Central Planning Authority

Agenda for a meeting of the Central Planning Authority to be held on **September 1, 2021 at 10:00Am, in Conference Room 1038, 1st Floor, Government Administration Building, Elgin Avenue.**

CPA/18/21

2.1 CAYMAN PROPERTY INVESTMENTS LTD (MJM Design Studio) Block 5B Parcel 162 (P21-0577) (\$820,000) (JP)

Figure 3: Survey data showing shoreline position/MWHM from 2003 to 2019 on 2018 aerial imagery

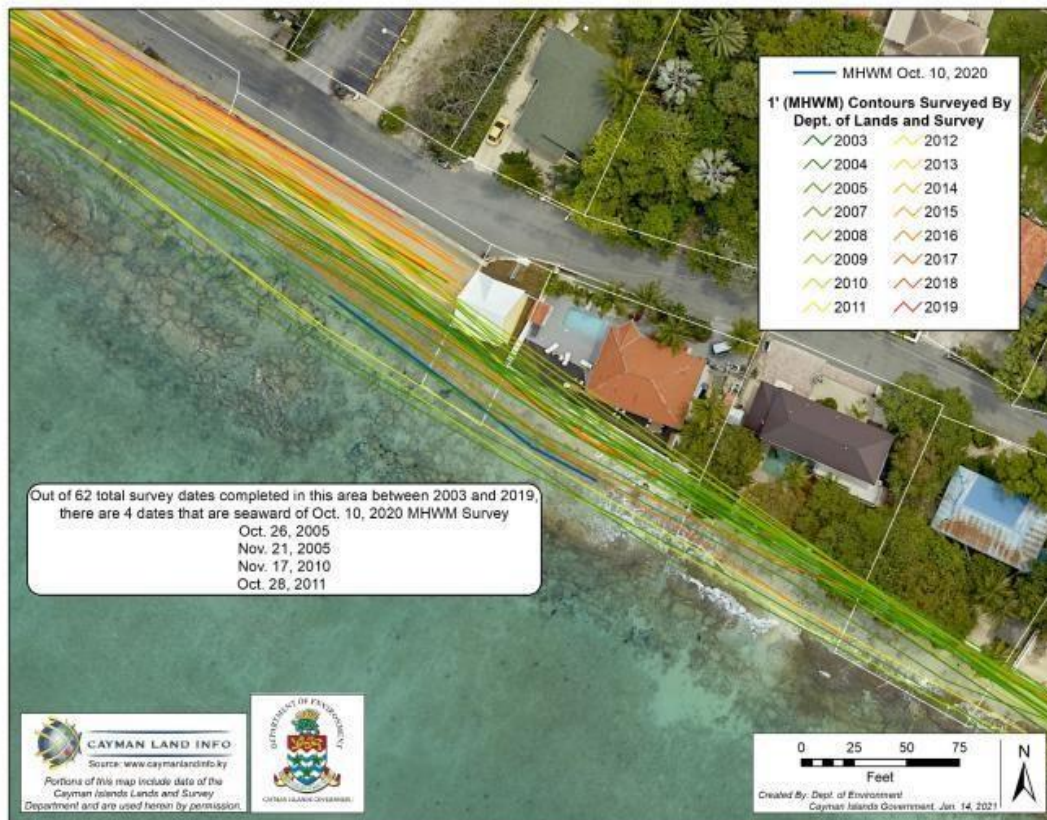
Figure 3 shows the surveyed position of the shoreline/MHWM at frequent time intervals from 2003 to 2019 (approximately monthly), based on survey data collected by the Department of Lands & Survey. Out of a total of 62 surveys undertaken in this location between 2003 and 2019, there were only 4 dates when the beach existed seaward of the October 2020 MHWM. Of these, the October and November 2005 accretion events can be attributed to Hurricane Wilma. The October 2011 accretion may be attributed to Hurricane Rina. Furthermore, as can be seen from Figure 3, the beach was completely absent for many of the survey dates (22).

The current MWHM survey reveals that the current seawall forms the boundary with the sea, and to the west of the site, incursion of the sea can be sea up to the Boggy Sand Road sheet piled seawall. Therefore, whilst the proposed seawall is positioned marginally further inland than the existing, the proposed seawall will also have a 0ft setback from the sea. The proposed cabana will have an 8ft setback from the existing seawall and an even lesser setback from the proposed seawall location.

Figure 4. Seawalls cause scour as the energy is reflected by the seawall.

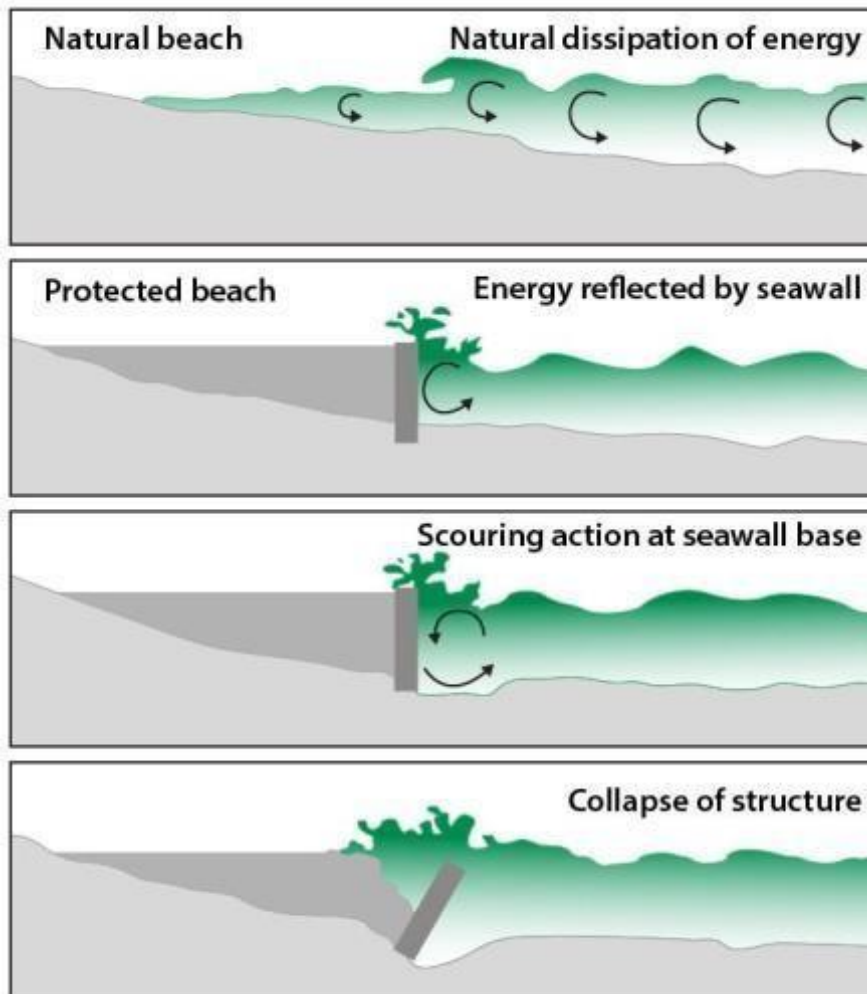
Hard structures such as seawalls on a beach, restrict the natural sand deposition processes. On a natural undeveloped beach, waves roll up the beach, depositing sand as they lose energy. However, seawalls interfere with this process. When waves hit a seawall, the energy is directed downwards and sideways. When the energy is directed downwards, the waves scoop out the sand at the foot of the seawall – called scour (see Figure 4). The existing seawall has caused scour at the site, as detailed in the Engineering Report which accompanies the planning application. When the energy is directed sideways, the wave

flanking can remove sand from neighbouring properties. Therefore, this seawall could also be negatively affecting the beach on adjoining parcels.
